# Application for "Other Business"

State specifically the need or reason(s) for Other Business:  
APPROVE FINAL SITE PLAN OF MCDONALD'S RESTAURANT ON PART OF THIS PARCEL.

Application No. Z-5

PETITION NO. Z-005

Min. Pk. Lot Pctition No. 2-5  
 Doc. Type Site Plan  
 Meeting Date 4 20 10

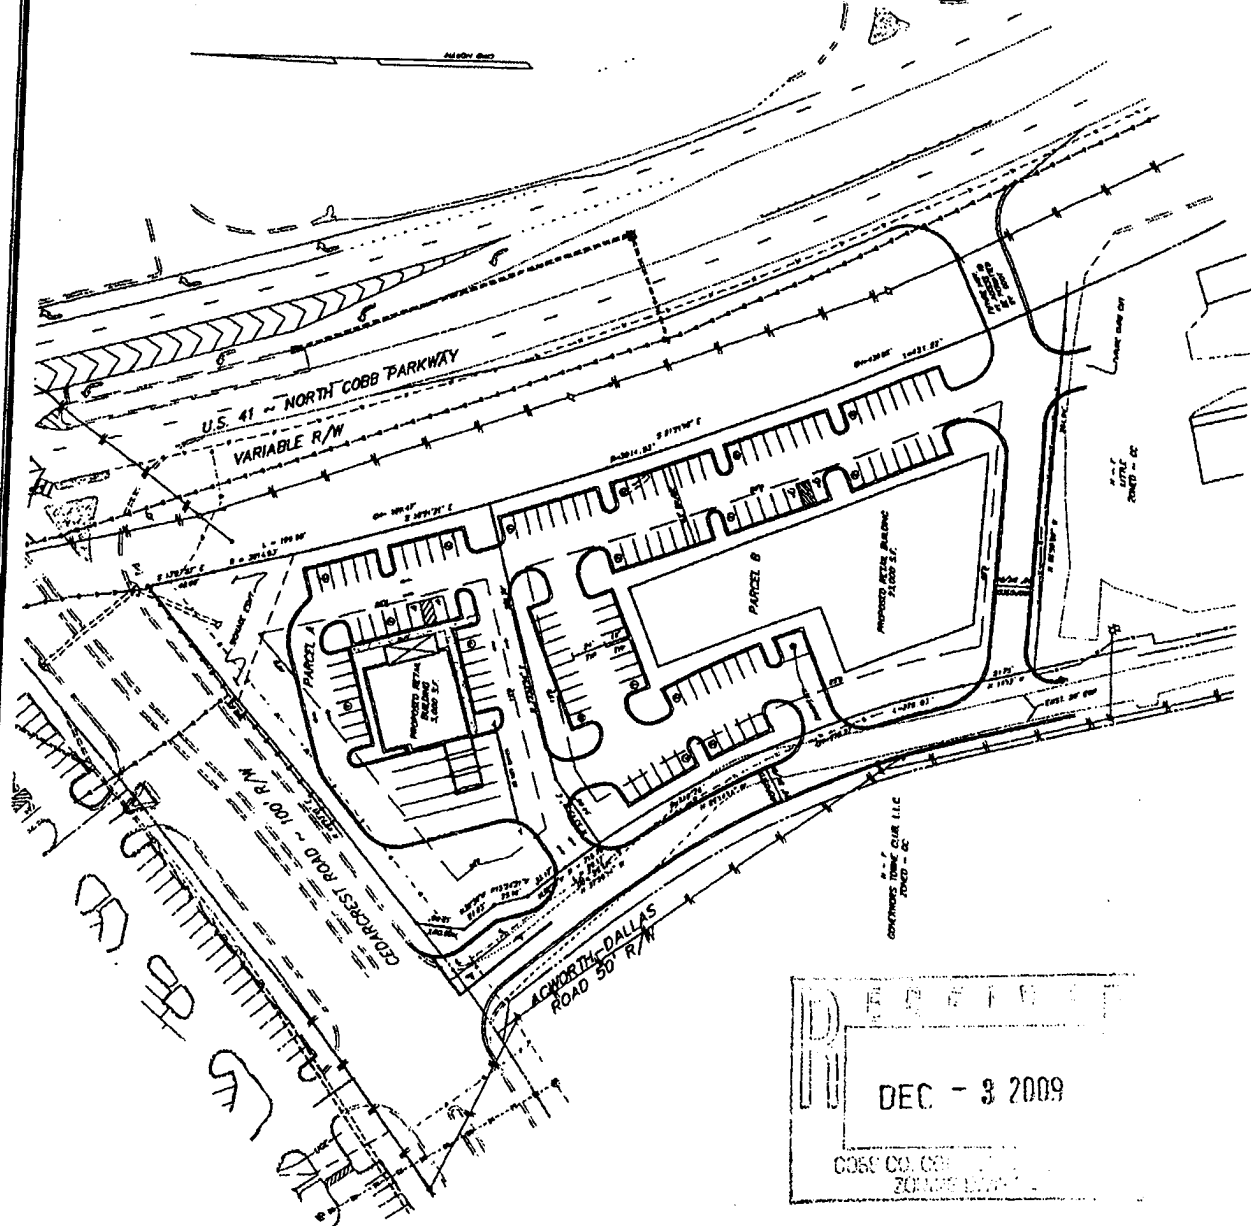
- Provide comprehensive hydrology/stormwater controls to include development of out parcels.
- Submit all proposed site improvements to Plan Review.
- Any **spring activity** uncovered must be addressed by a qualified geotechnical engineer (PE).
- Structural fill \_\_\_\_\_ must be placed under the direction of a qualified registered Georgia geotechnical engineer (PE).
- Existing facility.
- Project must comply with the Water Quality requirements of the CWA-NPDES-NPS Permit and County Water Quality Ordinance.
- Water Quality/Quantity contributions of the existing lake/pond on site must be continued as baseline conditions into proposed project.
- Calculate and provide % impervious of project site.
- Revisit design; reduce pavement area to reduce runoff and pollution.

- No Stormwater controls shown \_\_\_\_\_
- Copy of survey is not current - Additional comments may be forthcoming when current site conditions are exposed.
- No site improvements showing on exhibit.

Acworth Dallas Road is not located as shown on the proposed plan. A right-of-way swap needs to be executed for the relocated Acworth Dallas Road.

MOTION: Motion by Ott, second by Goreham, as part of the Consent Agenda, to **approve** Rezoning to the NRC zoning district subject to:

- Parcel A and road improvements as shown on the site plan received by the Zoning Division December 3, 2009 subject to Plan Review and approval by the District Commissioner (attached and made a part of these minutes)

- improvements on Parcel B of the December 3, 2009 plan subject to Plan Review, with final approval by the Board of Commissioners
- right-in/right-out only exit onto US 41 to be completed as part of the first phase of development (before Certificate of Occupancy is issued for any building)
